163x +5V Rail

The +5V rail in a 1630 series analyser can cause the microprocessor to “reset” if the rail drops to 4.93V. This note lists the known common causes and cures for a poor quality 5V rail.

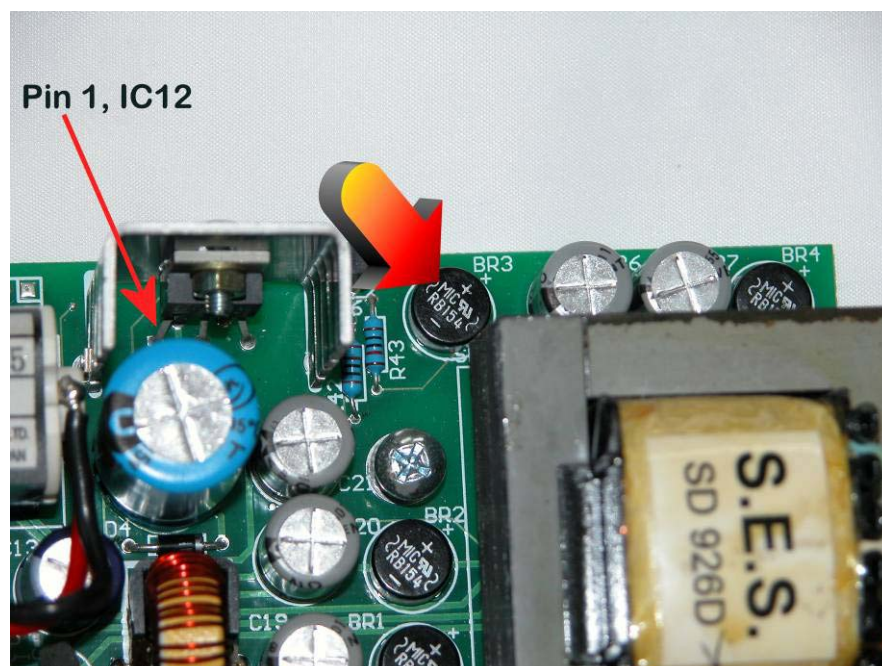
- 2) The bridge rectifier, BR3, has an open circuit diode reducing the available power from the 5V rail. This can be confirmed measuring the pre-regulated DC voltage on pin 1 of IC12, this should be between 14 & 18VDC, or by using a CRO. Replace BR3 and make sure the component is installed so there is at least 3mm between the component and the circuit board. This helps the component to dissipate heat.
